## PURCHASING MEMORANDUM

### BID SOLICITATION UPDATE

**IFB NUMBER:** 22341

**GROUP:** 35800 -Comprehensive Traffic Operation  
Control & Monitoring Systems: Equipment & Products;  
Systems & Components (including Hardware & Sensors;  
Options, Accessories, Parts & Supplies) (Statewide)

**Page 289 – Chapter 13 – Section 3 – Paragraph 11.1 - Figure 13.14**

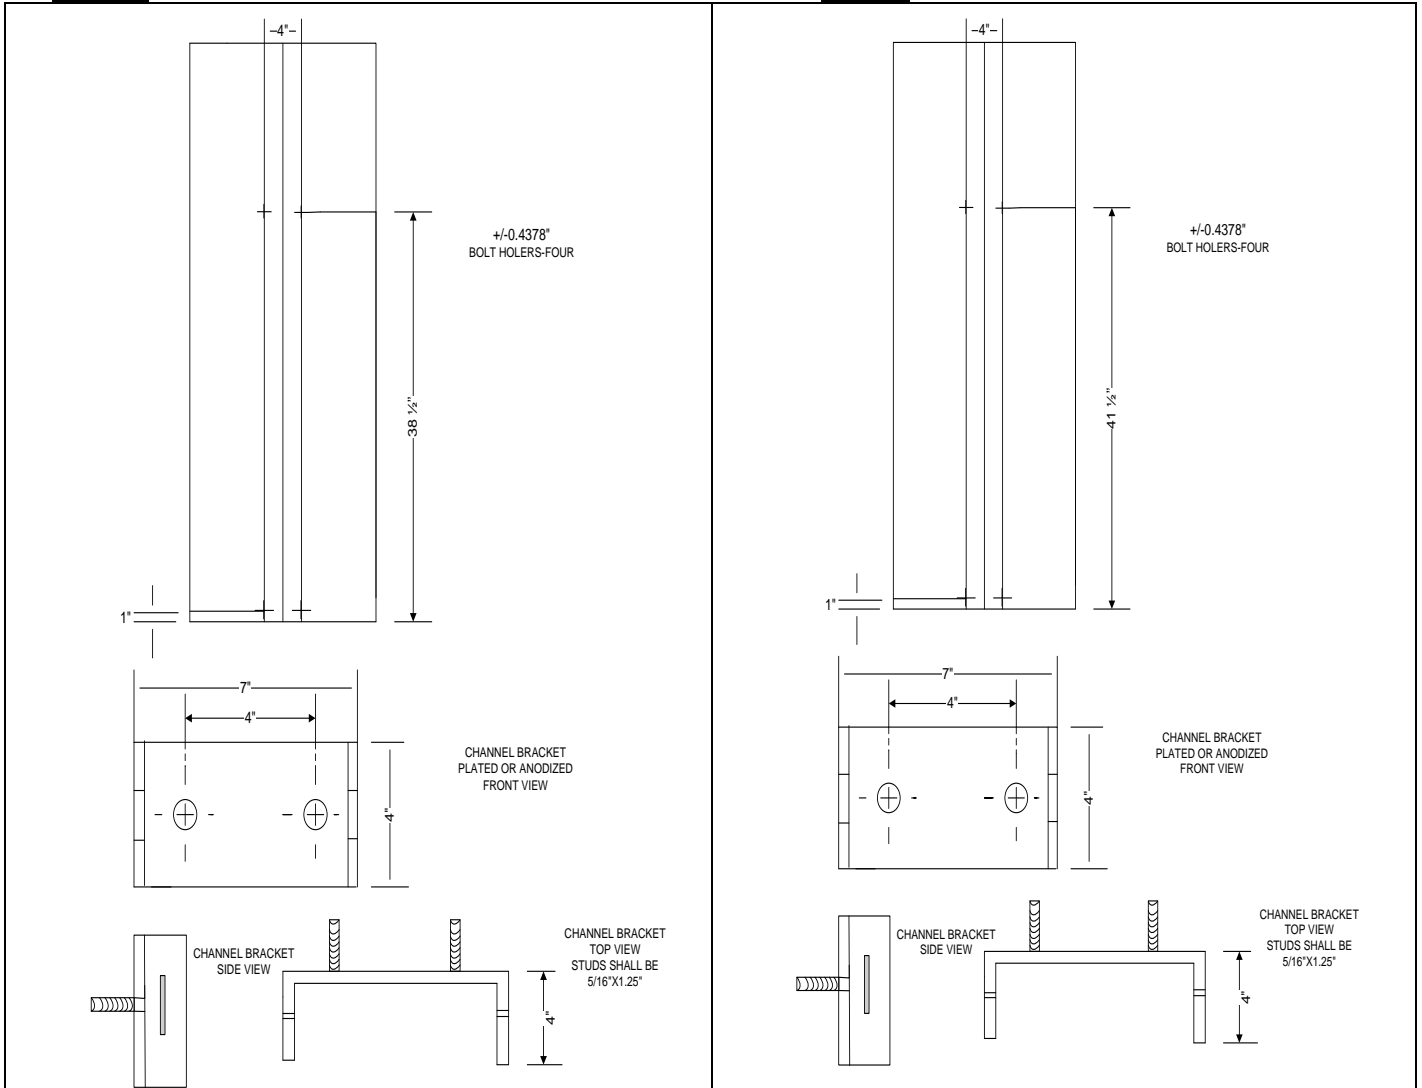
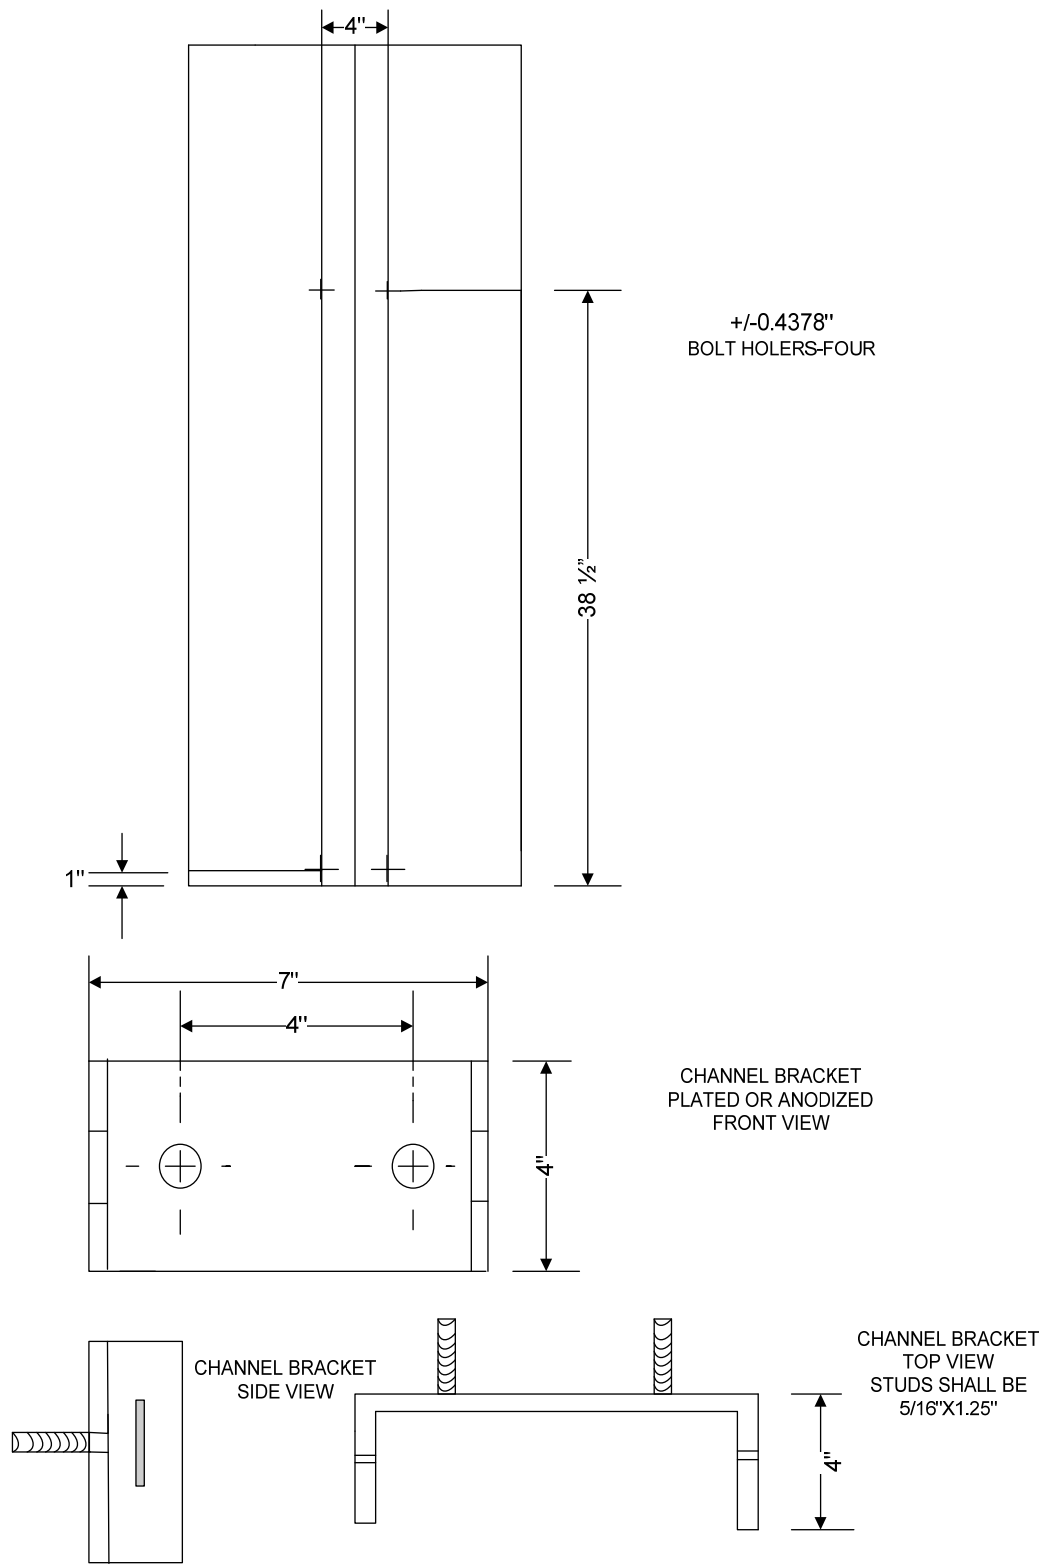
The 39 ½ inch height designated for the bolt holder position in the upper section of the drawing has been raised to a height of 41 ½ inches.

**Page 282 – Chapter 13 – Section 3 – Paragraph 11.1 - Figure 13.8**

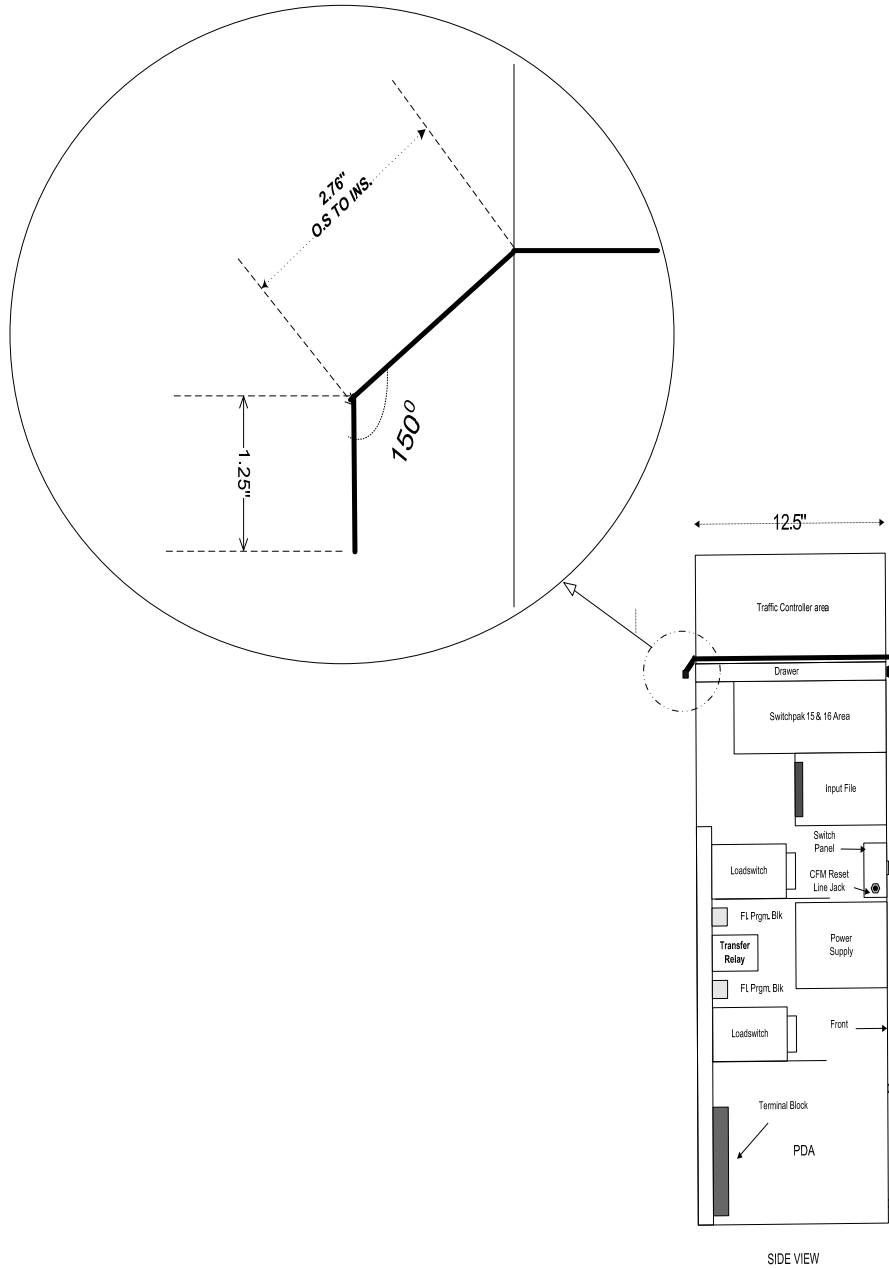
*Remove the Fixed angle value of 150° from the Shelf Cover illustration in the inset circle’s exploded view.*
